THE MEADOWS AT BAILEY CANYON SPECIFIC PLAN

Planning Commission

Public Hearing – May 5, 2022

PLANNING COMMISSION DELIBERATIONS

OPTION 1
SECTION - CARTER AVE.
24' CURB TO CURB WITH NO PARKING
AND 8' SIDEWALK ON NORTH SIDE
1" = 10'

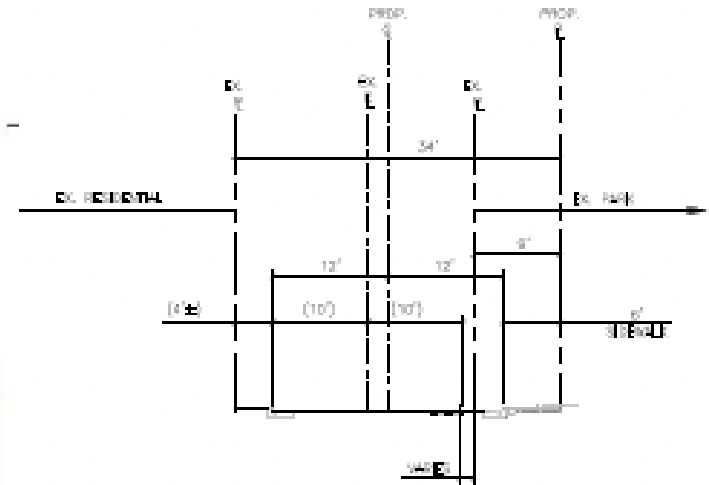
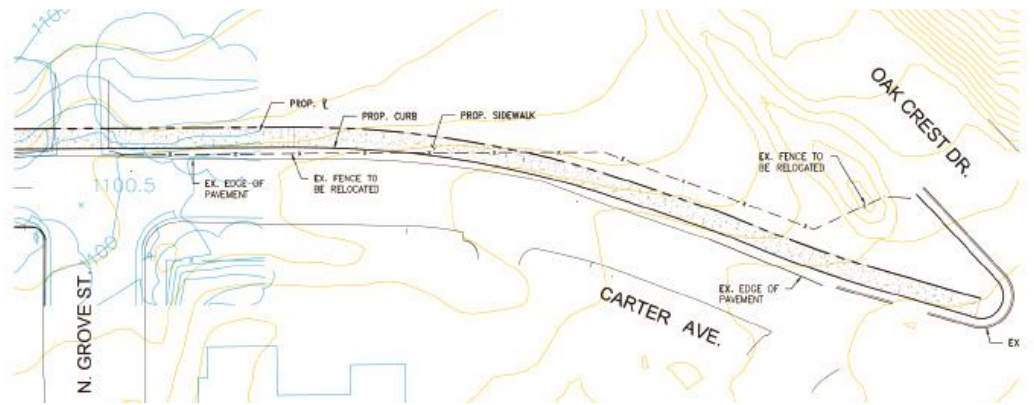
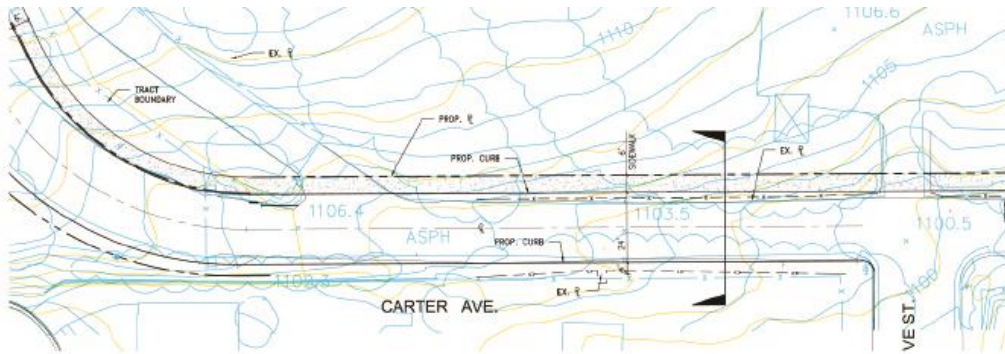
6. Update the Commission on discussions with the County regarding road widening

- Applicant held three meetings with the County
- Preliminary application for County feedback is in progress

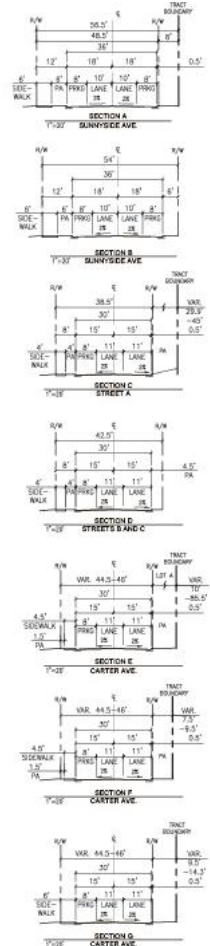
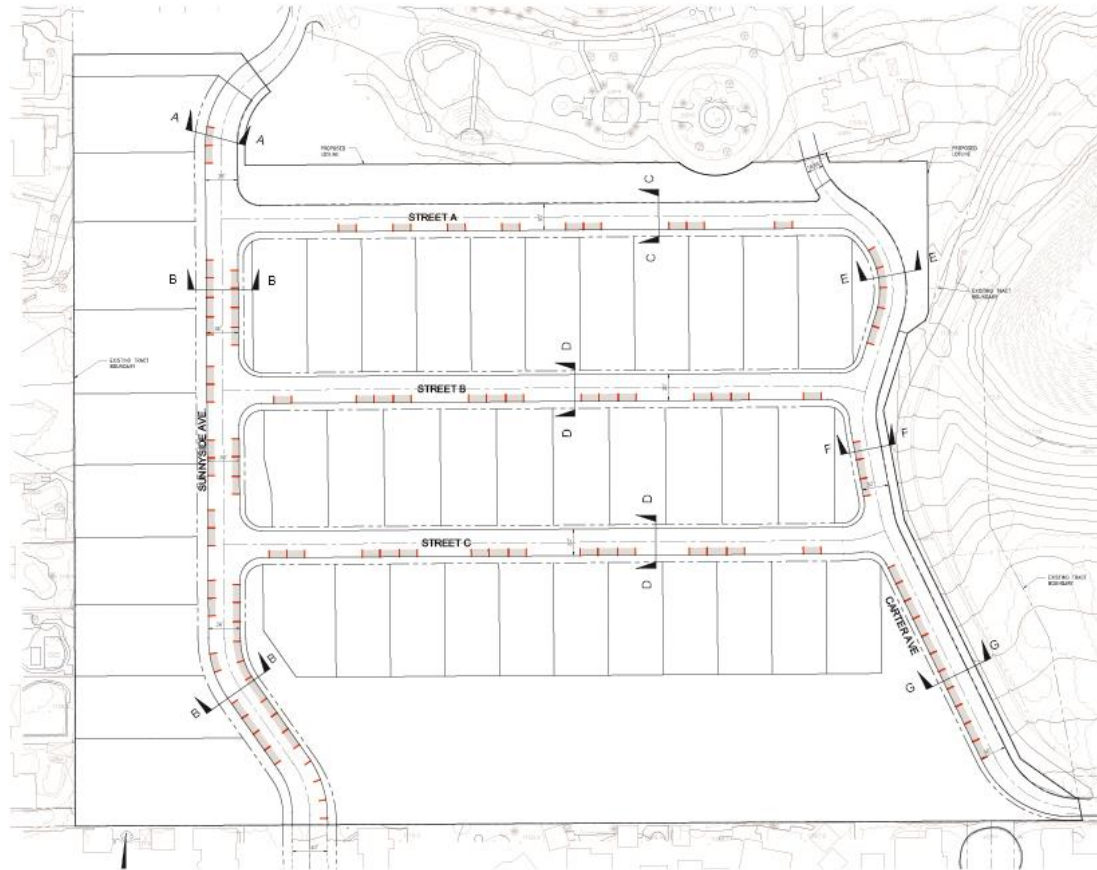
9. Provide more information regarding connection to parking and access related to Bailey Canyon Wilderness Park

97 total public parking spaces provided within the project site.

97
Total on-street
Parking Spaces

37
Total Parking
Spaces along
Sunnyside Ave.

19
Total Parking
Spaces along
Carter Ave.

7
Parking Spaces in
proposed park

CARTER SIDEWALK-OPTIONS 1 AND 2

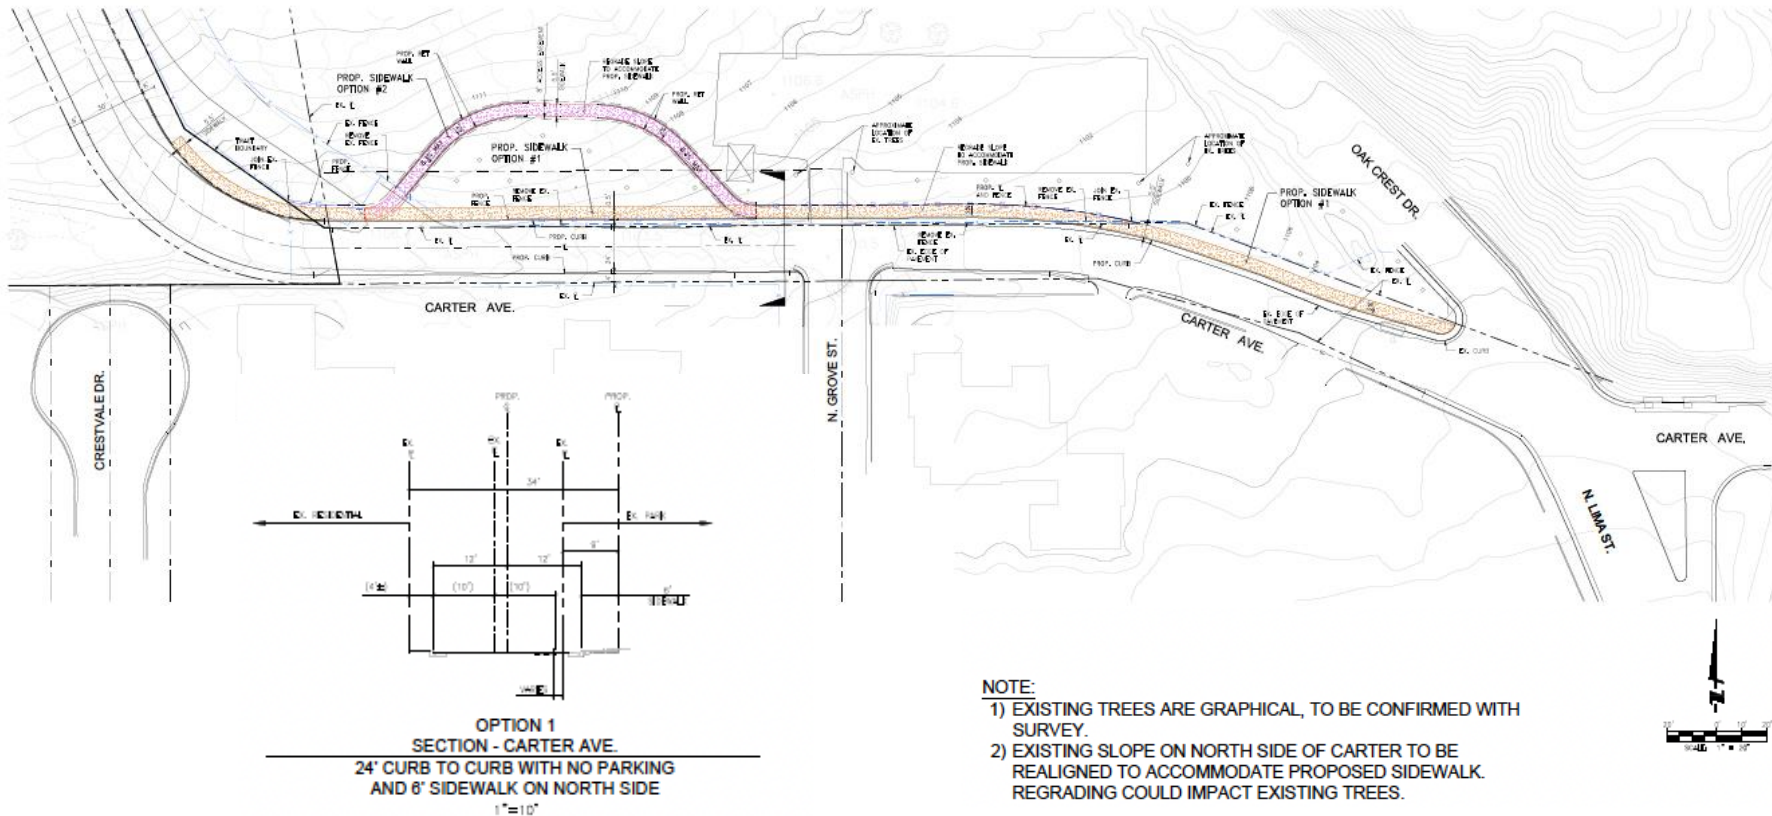
9. Provide more information regarding connection to parking and access related to Bailey Canyon Wilderness Park

Carter Roadway sidewalk options:
Both options must comply with ADA requirements
Option 1 results in the removal of 4 Cypress trees
Option 2 in purple retains trees

BAILEY CANYON PARK ACCESS EXHIBIT
SIERRA MADRE, CA
MAY 3, 2022

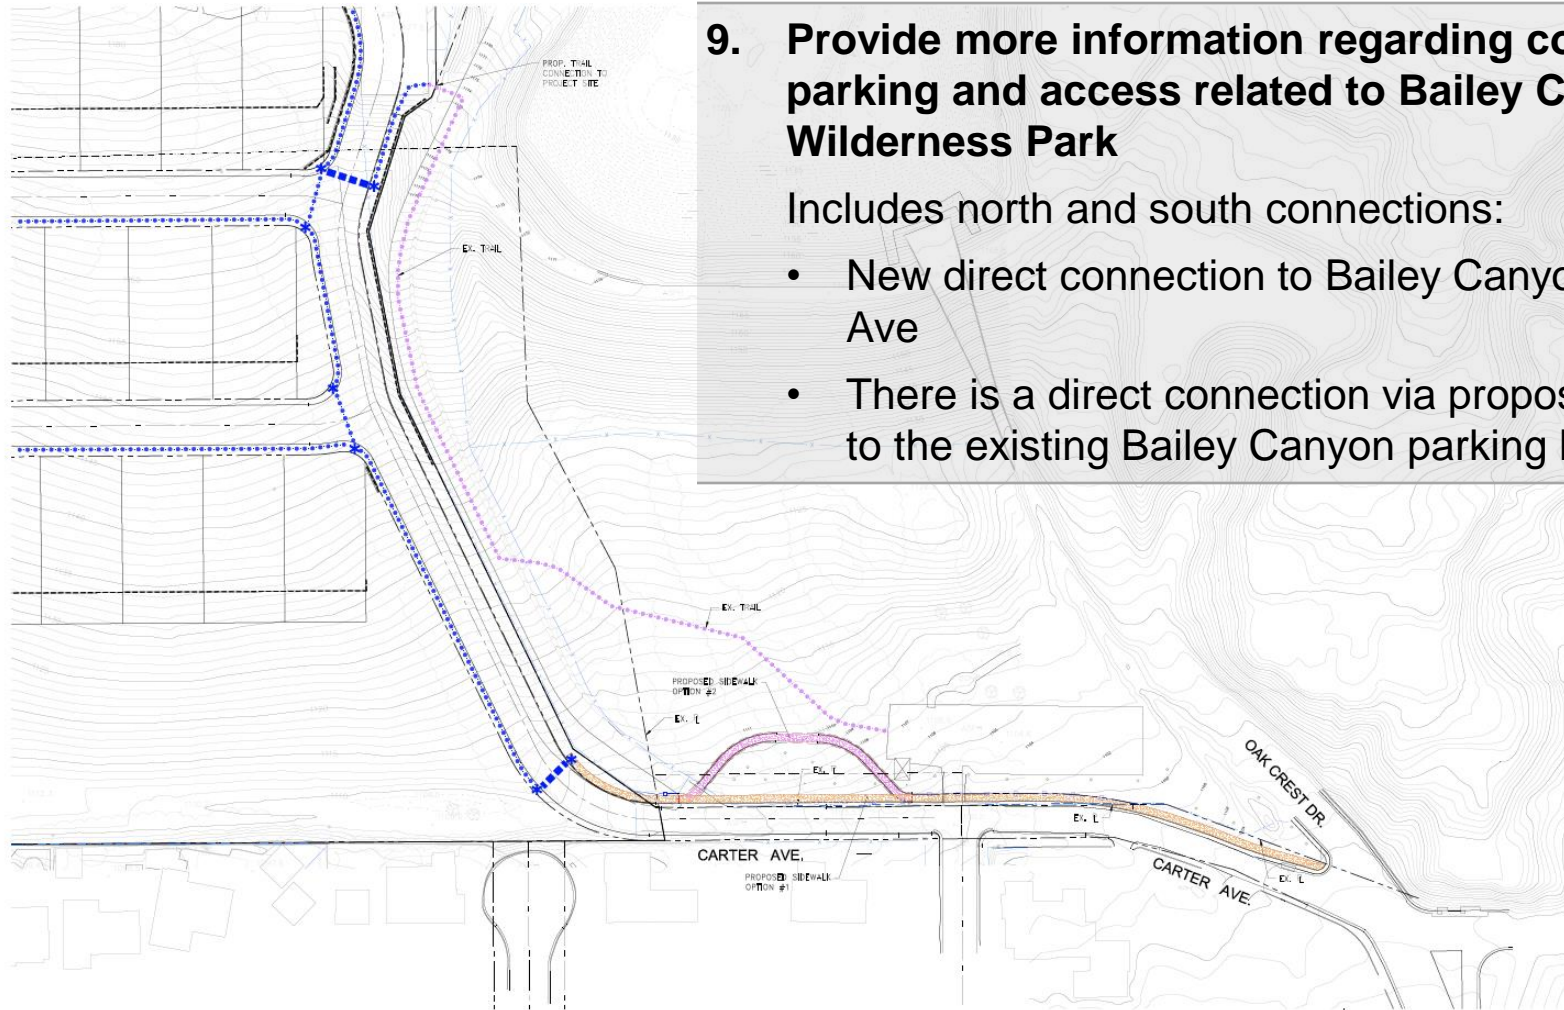
9. Provide more information regarding connection to parking and access related to Bailey Canyon Wilderness Park

Includes north and south connections:

- New direct connection to Bailey Canyon from Carter Ave
- There is a direct connection via proposed sidewalk to the existing Bailey Canyon parking lot

Tree Locations within the Alternative Sidewalk Alignment

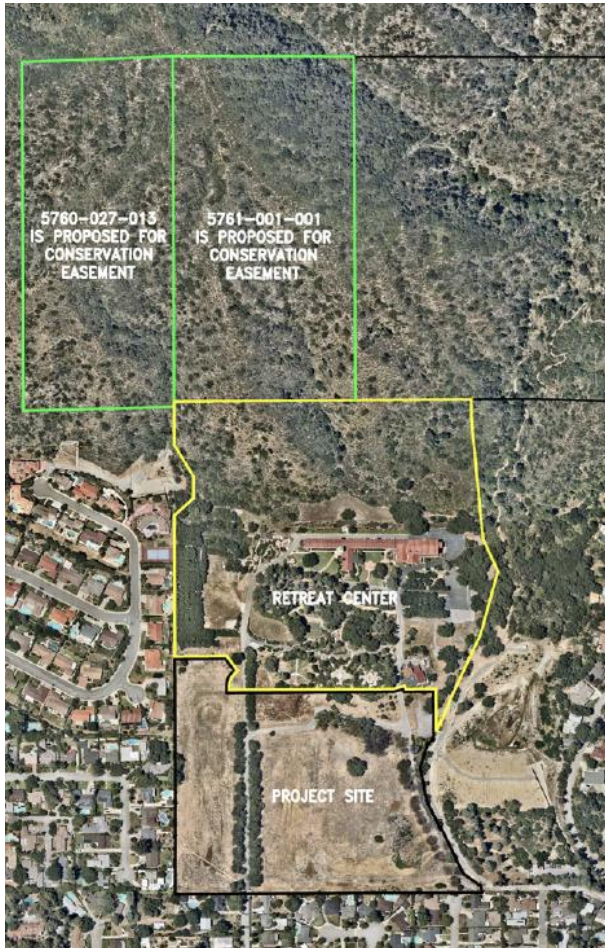
9. Provide more information regarding connection to parking and access related to Bailey Canyon Wilderness Park

Both a north and south connection; new direct connection to Bailey Canyon from Carter Ave. There is a direct connection via proposed sidewalk to the existing Bailey Canyon parking lot.
